Bug Fix for htn calculation in get_PSDs

COM Commit Request Number 4p9_6

Adam Gregory, Samtec

Include final noise sample

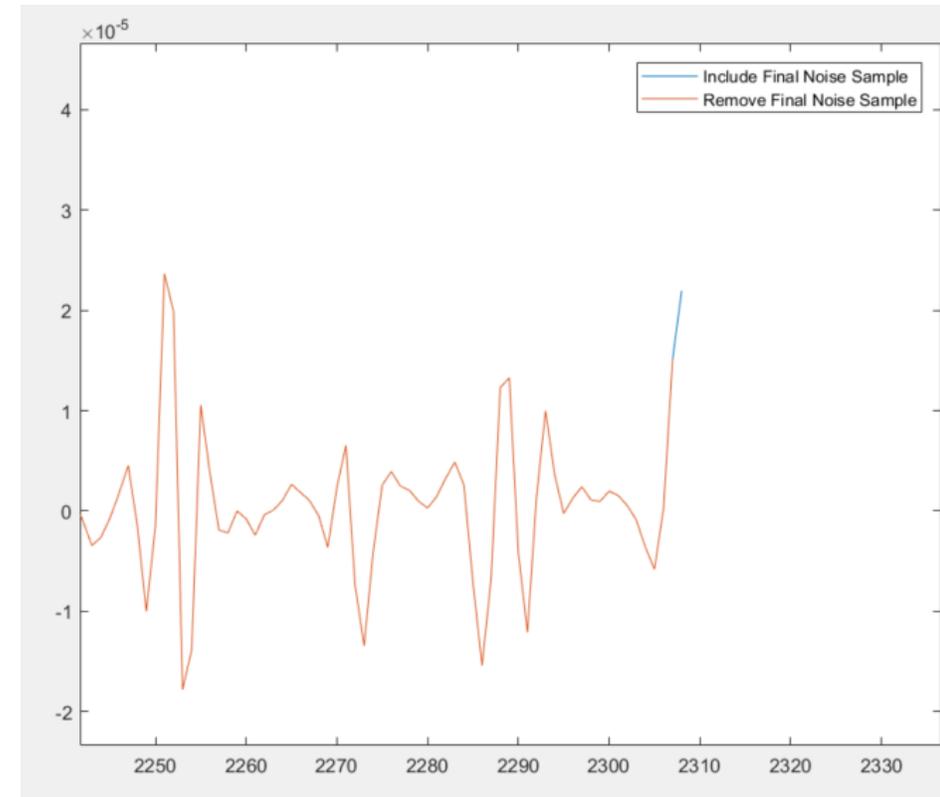
```
140 - htn=[ htn(1:floor(length(htn)/M)*M) ];  
141 - htn= [htn zeros(1,num_ui*M-length(htn)) ];
```

- Remove these 2 lines. They are not necessary to align the length of htn to proper number of UI. In addition, the first line uses “floor”, so it will chop off the last noise point unless the length is already an exact multiple of M.
- The final noise sample should be very small, so this update will have no meaningful impact.
 - The plot shows an example of including vs. removing. The extra noise is about 20uV
